25/P/01522 Full planning application for the erection of residential apartment blocks and townhouses (248 Use Class C3 units), with associated site preparation works, cycle and vehicle parking, highway and access improvements, children's play space, public realm enhancements, tree works and landscaping.

The Society Objects to this application.

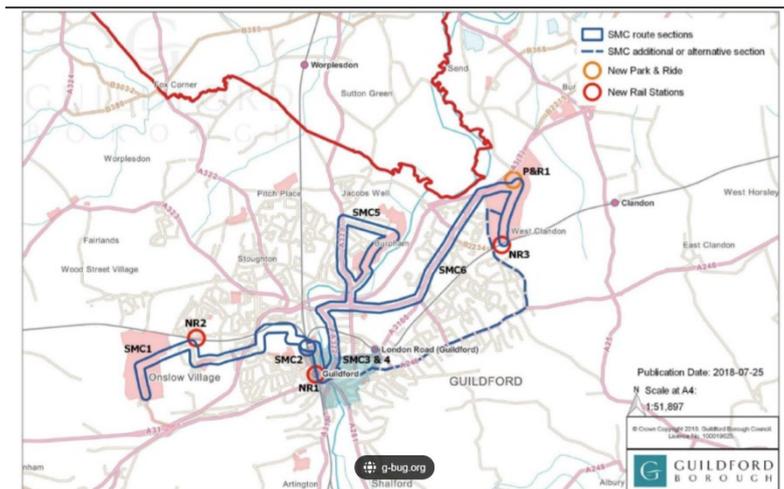
For the 233 flats there is limited public amenity space. The scheme relies heavily on the Living Street to provide its public realm. Flat dwellers only public amenity is the living street-poor environment with it's 6.2m wide road or bits of landscaped area left over by the siting of the flat blocks. There are no proper public spaces which might be desirable places for flat dwellers to use and enjoy. Most flats do have a balcony for private amenity space although again these do not satisfy the requirements of the Heights SPD. There is a play area but located at the north end of the development requires children, with or without parents/escorts, from all parts of the development to cross the main road.

The design is cramped and overcomplicated with its multiplicity of paths and areas, having more open grass areas could be preferable to allow residents to organise how they use the site themselves?

The absence of roof gardens represents a missed opportunity which Roof gardens could be part of a green roof sustainability plan, would be better visually and would provide excellent

shared amenity spaces encouraging a sense of community. Note the PV Cells lost on a roof might be replaced by incorporating PV cells as part of the facades as has been done very successfully in many modern buildings.

The Amenity space is very limited for the 700+ future residents.

We fail to see that the current proposals adhere to these and other requirements of the Tall Buildings SPD. If the Council fails to follow its own policies, it will not be possible for the Council to insist that developers of other projects adhere.
